PRODUCT CHANGE NOTIFICATION

Date: August 12, 2014
PCN: PCN LEDIL 97 a

Subject: PCN 97a - CS12862_STRADA-IP-2X6-DWC product improvement

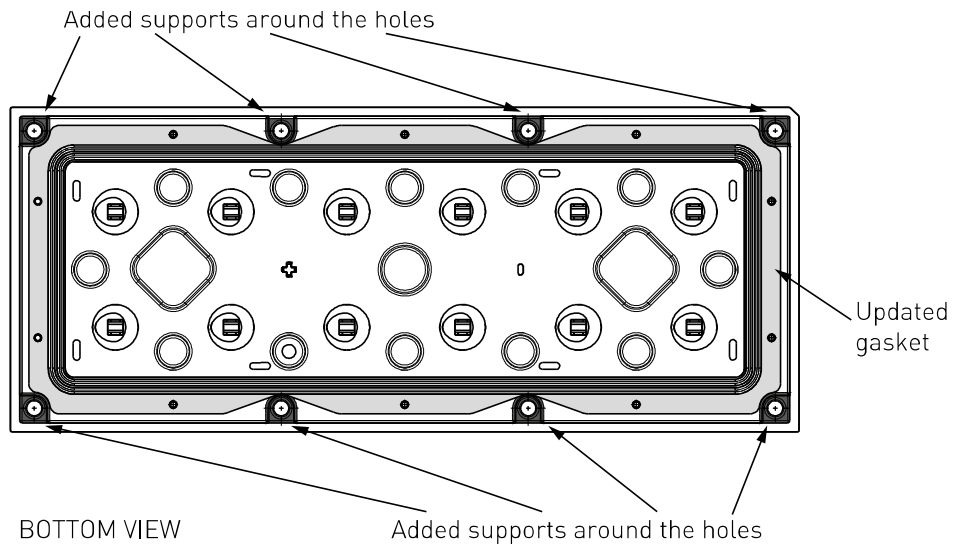
Changes: There are added supports around the eight fastening screw holes and the silicone gasket has been replaced to the latest version. There aren't any changes made into optical parts of the product. Please see the below drawing for details
